PROPOSED MULTI-FAMILY PROJECT
 HWY 51
 CHARLOTTE, N. CAROLINA

TECHNICAL DATA SHEET

CHARLOTTE-MECKLENBURG PLANNING COMMISSION
INTER-OFFICE COMMUNICATION

DATE: August 17, 1995
 TO: Robert Brandon, Zoning Administrator
 FROM: Martin R. Cramton, Jr., Planning Director
 SUBJECT: Administrative Approval for Petition No. 94-14(c) by Brock Consulting Group Inc., Tax Parcel No. 213-051-08

CONCEPTUAL PLAN

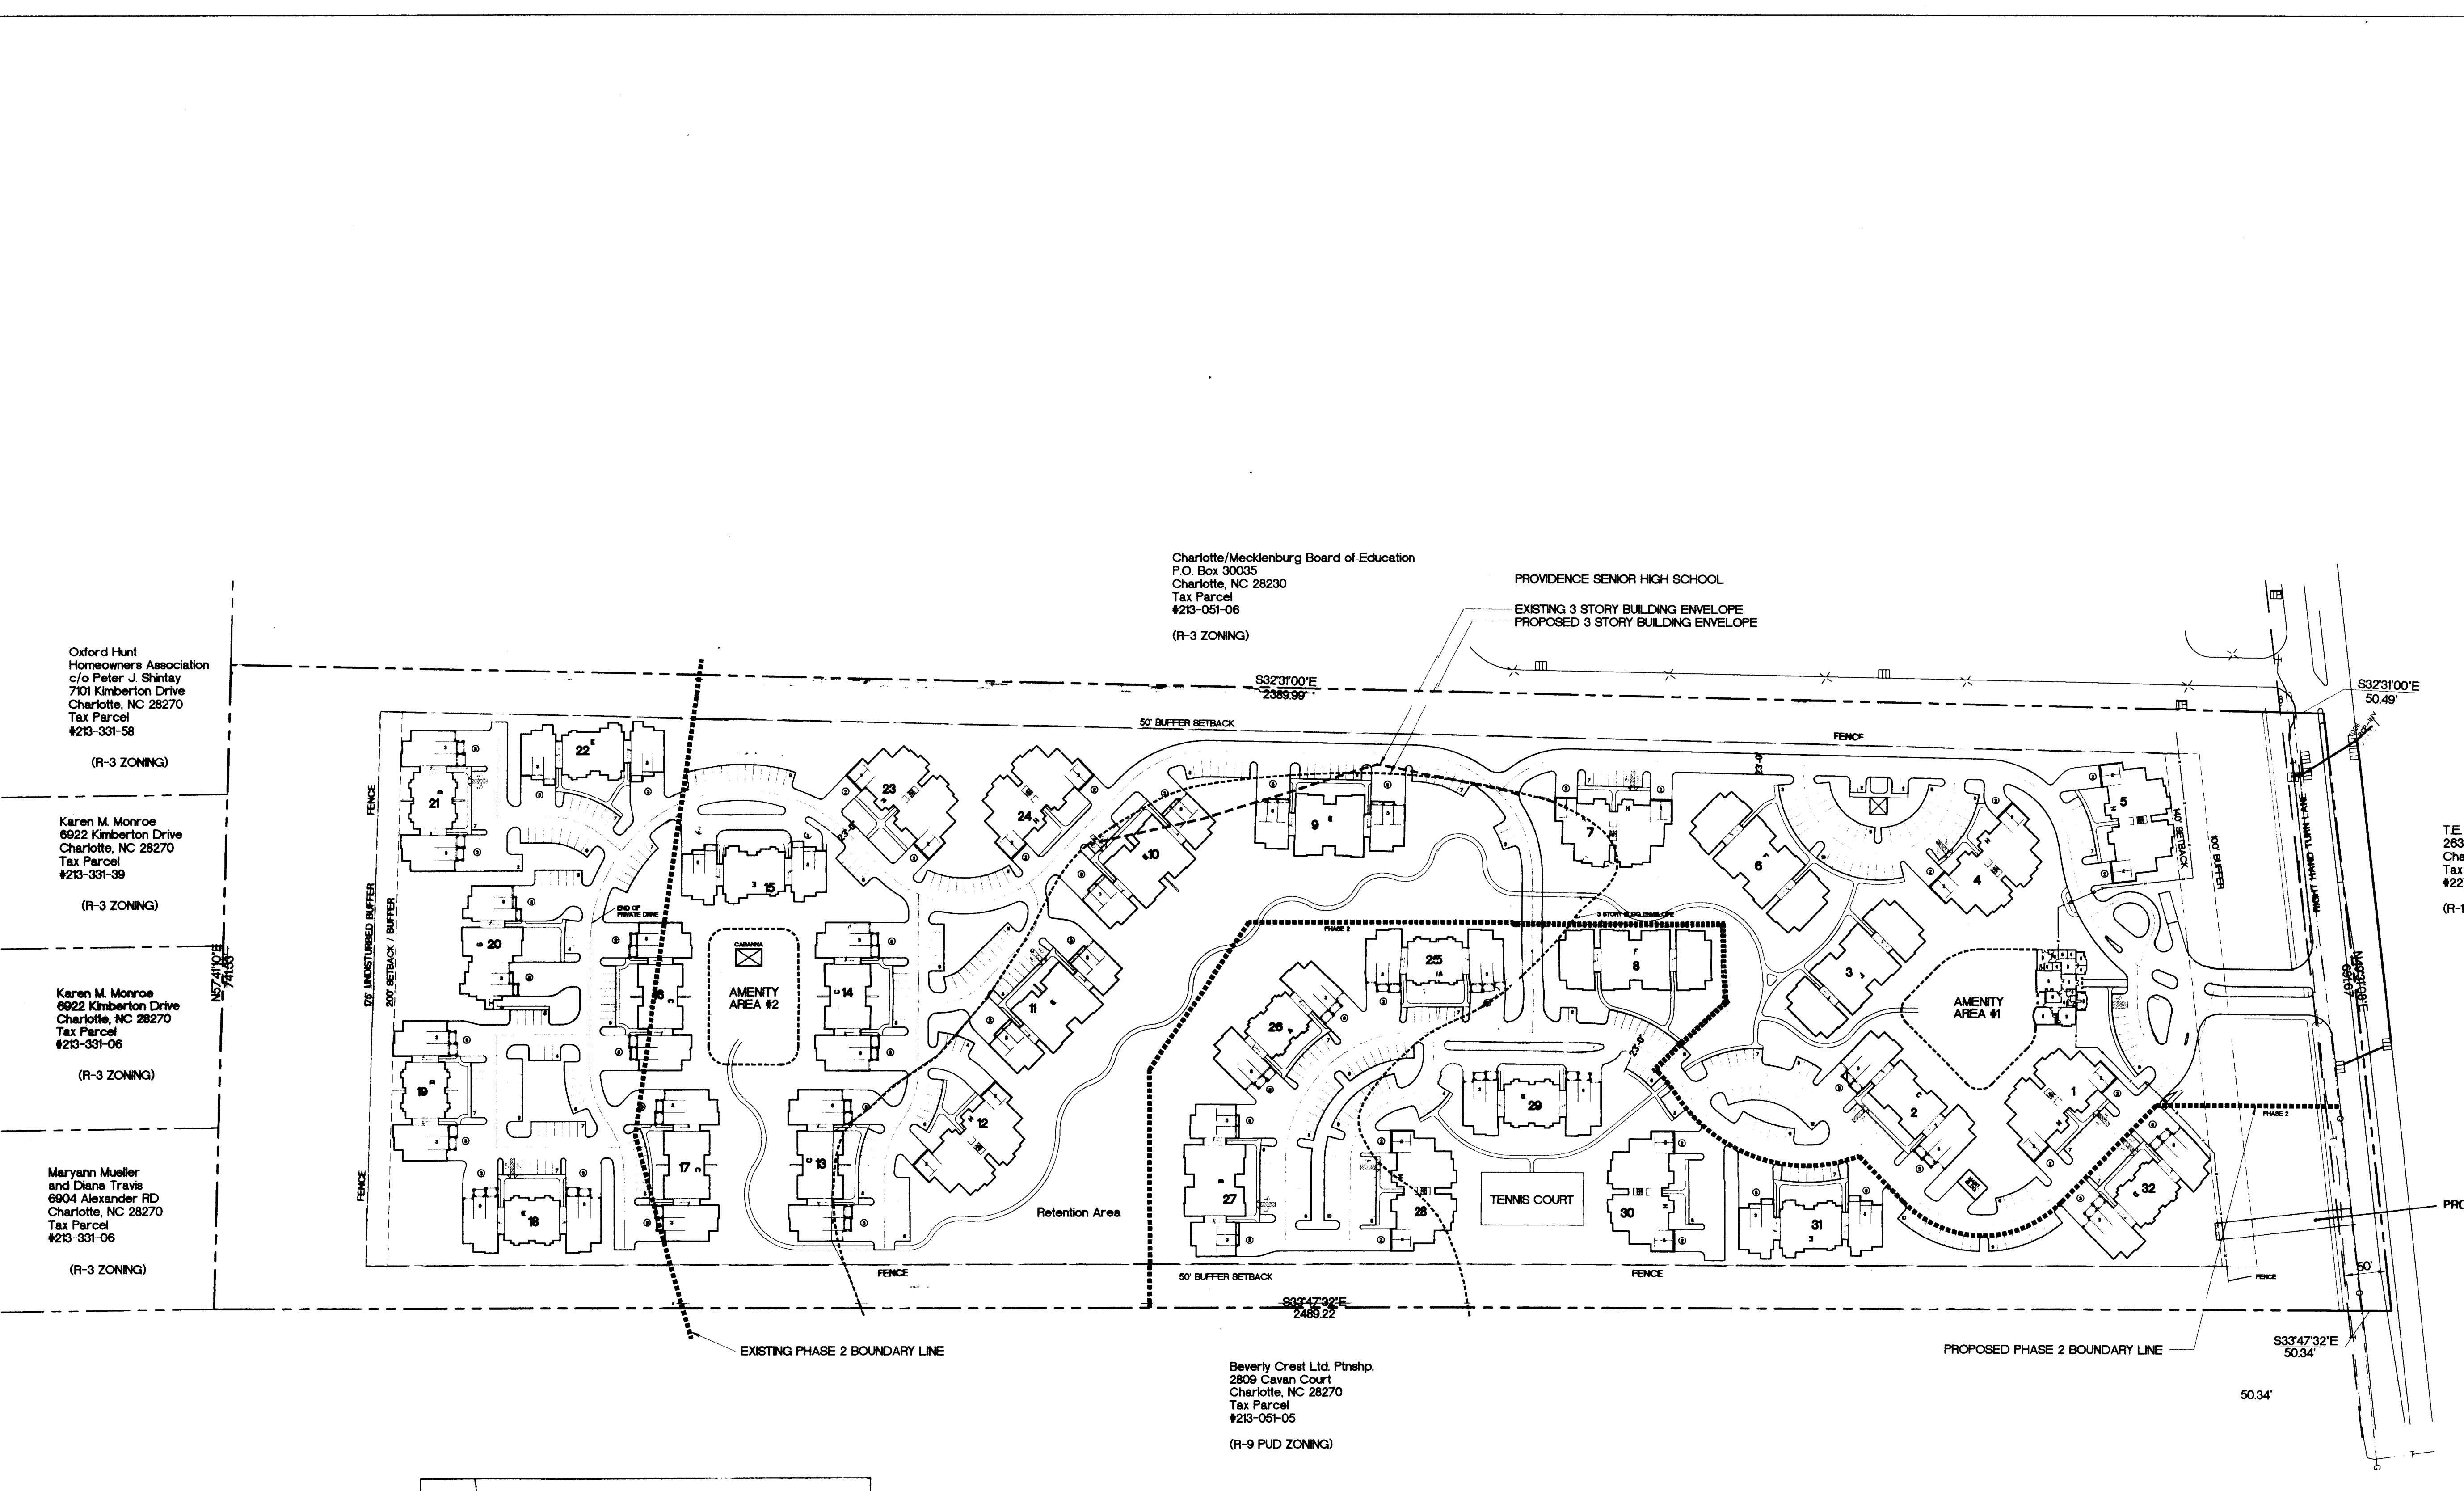
- Attached is a revised site plan for the above referenced rezoning petition. This site plan has been revised to:
- Adjust the Phase 2 boundary line from the north edge of the property to the southwest quadrant. Phasing of units will include 292 in Phase 1 and 128 in Phase 2.

- Show a Phase 2 construction entrance independent of the primary project entrance.
 - Increase site coverage (buildings, driveways, and parking) from 596,391 sf (34.23%) to 615,753 sf (35.34%).

- To reduce open space from 65.77% to 46.56%.
 - To slightly adjust the 3 story building envelope line to accommodate (6) 3/2 split buildings 9, 10, 11, 25, 26, 27.

- To reduce the minimum fire lane width from 24'-0" to 23'-0" based upon verbal approval by the City of Charlotte Fire Department.
- Since these changes are minor and the intent of the originally approved plan has been met in this revised site plan then I am approving these changes administratively. Please use this revised site plan when evaluating requests for building permits and certificates of occupancy.

Buffer Mitigation Plan

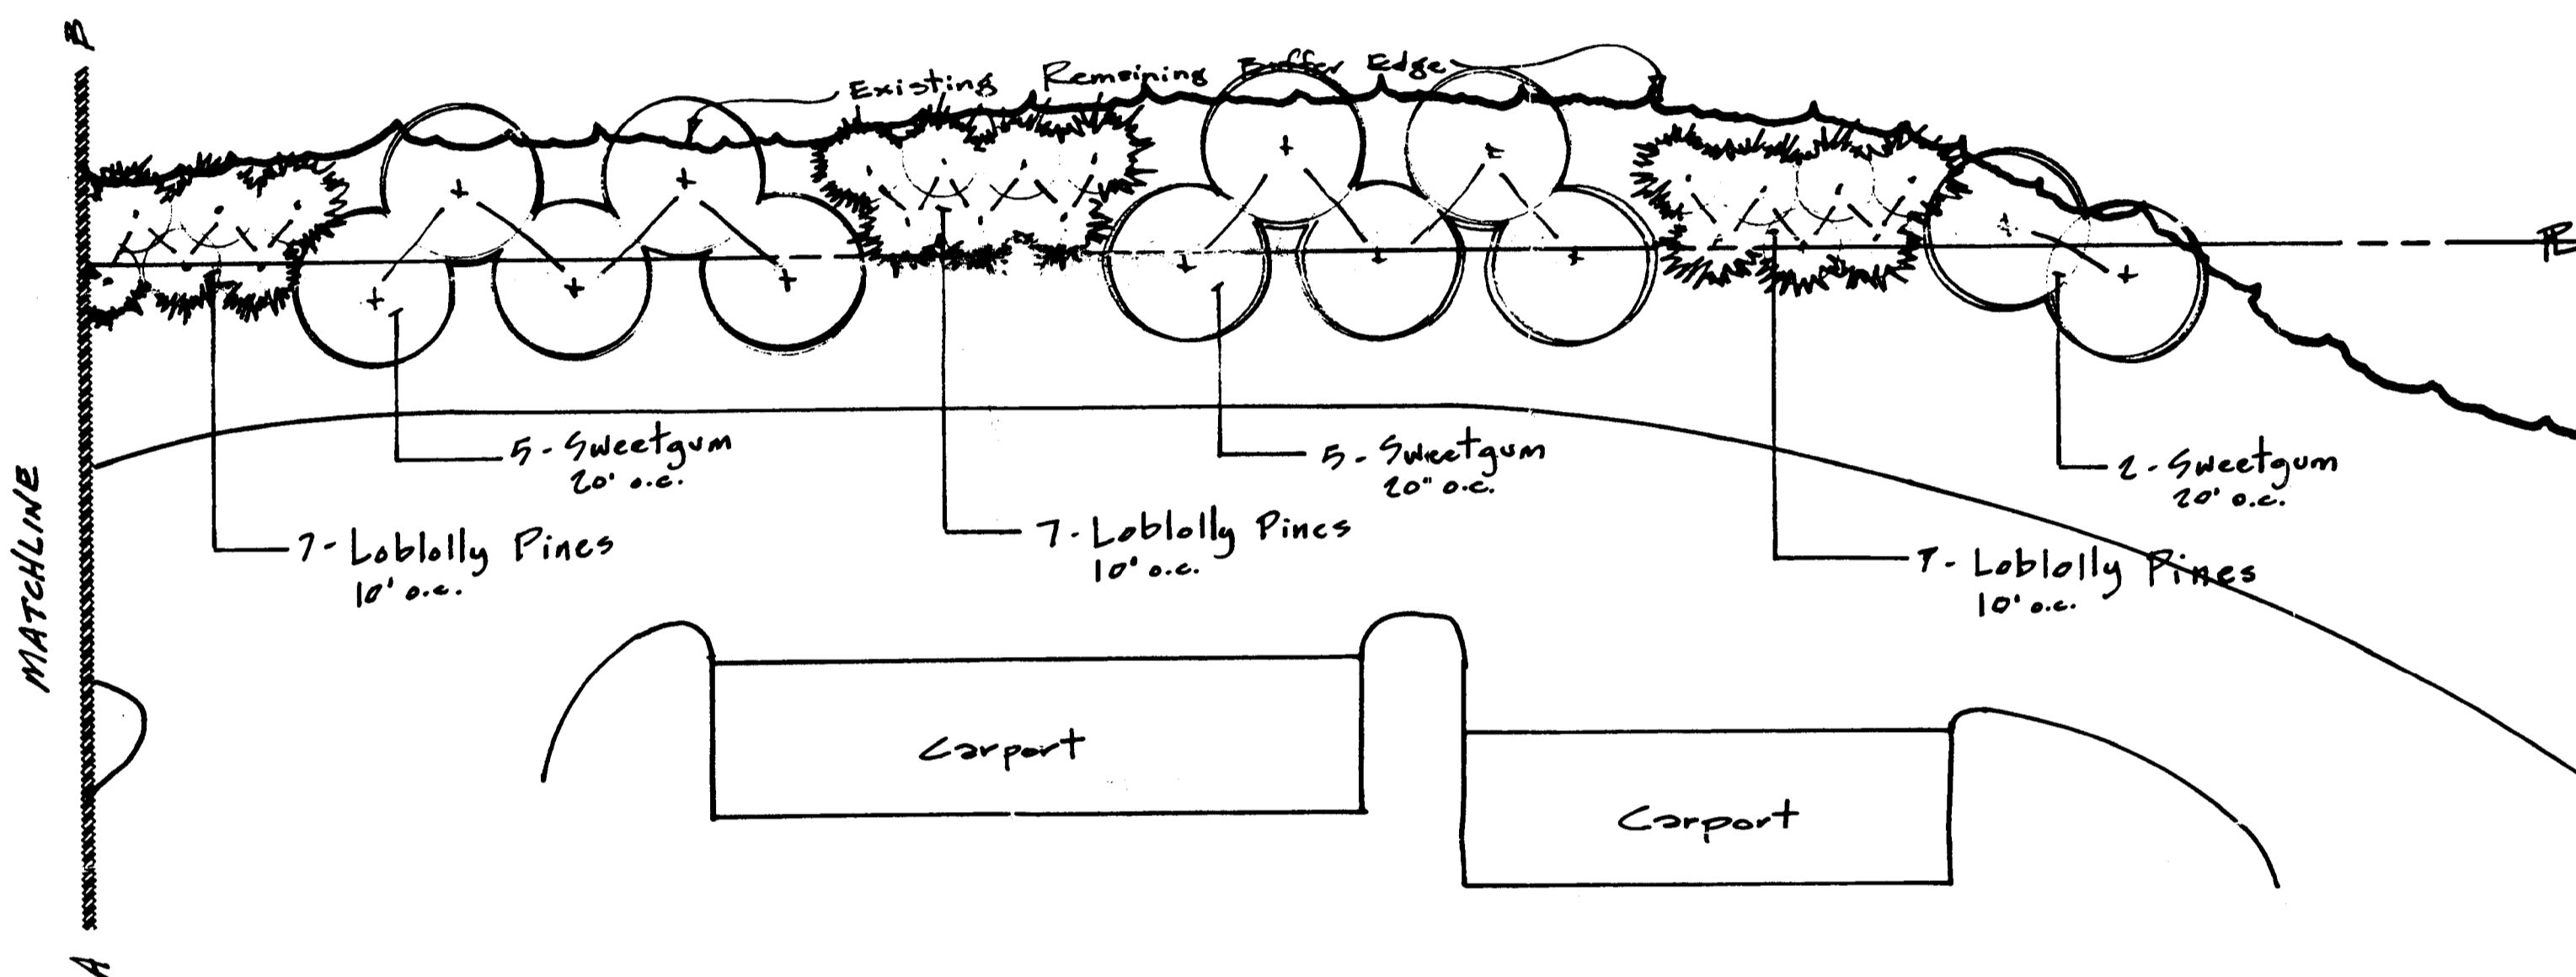
Attached is a specific landscape plan for the re-vegetation of the 50 buffer along the westerly property line of the above mentioned rezoning petition. This buffer was partially cleared by the developer of the adjacent multi-family development. As a result of this clearing the adjacent developer was required to plant new trees within the buffer. The attached plan represents what he was required to plant. Please use this attached plan when evaluating request for building permits and certificates of occupancy.

Total Linear Footage of Buffer Encroachment: 650'
 12 Trees per 100' Encroachment = 78 required trees

Number of Trees shown: 32 Large Maturing Trees (41%)
 +46 Evergreen Trees (59%)
 78 Total Trees
